# Technical Service Bulletin

## 01 Engine Crankcase breather Whistling Noise and DTC P227900 warning light ON

01 23 59 2069351/3 June 28, 2023. Supersedes Technical Service Bulletin Group 01 number 23-44 dated February 13, 2023, for reasons listed below.

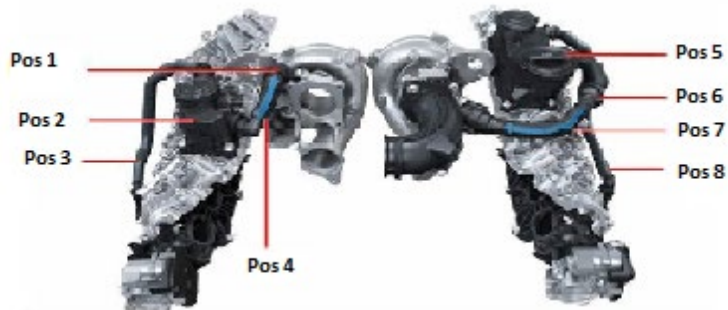
Improved crankcase full load breather line for bank 1 have been implemented in production between the end of Q2 2021 and the start of Q4 2021, depending on engine version. See table below:

In this case, replace the full load breather line for cylinder bank 1.

1. Do not replace the oil separator for bank 1 or bank 2 or the part load breather lines.
2. Please refer to image of the crankcase breather from the Self Study Program 920493 as a guide.

**Item 4: Full load breather line for bank 1 (Replacement required)**
